ADDENDUM # 1

Date: 12/8/2023

RFQ #2904 Crowders Creek Pump Station Replacement Project

**MANHOLE
OUTSIDE DROP**

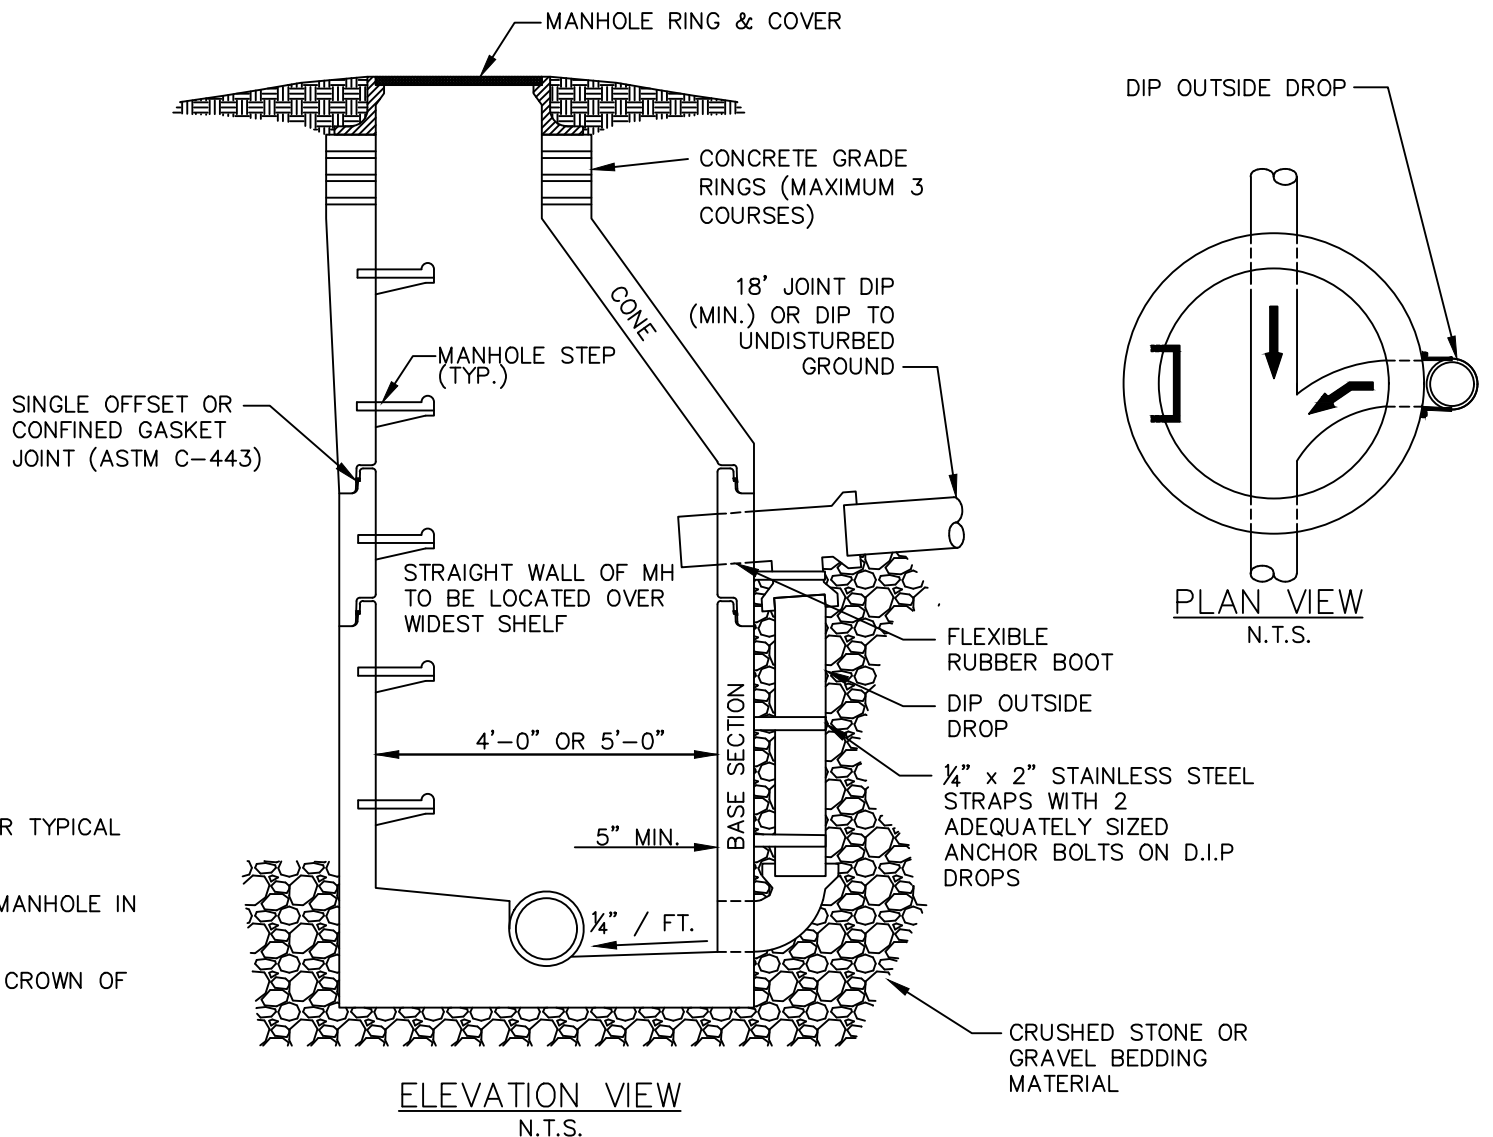
Change 8: Add the attached Outside Drop Manhole detail to Sheet C704

1. REFER TO STANDARD NO. 12.01 FOR TYPICAL MANHOLE REQUIREMENTS.
2. OUTSIDE DROP SHALL NOT ENTER MANHOLE IN CONE SECTION.
3. MATCH DROP INFLUENT CROWN TO CROWN OF EFFLUENT PIPE.
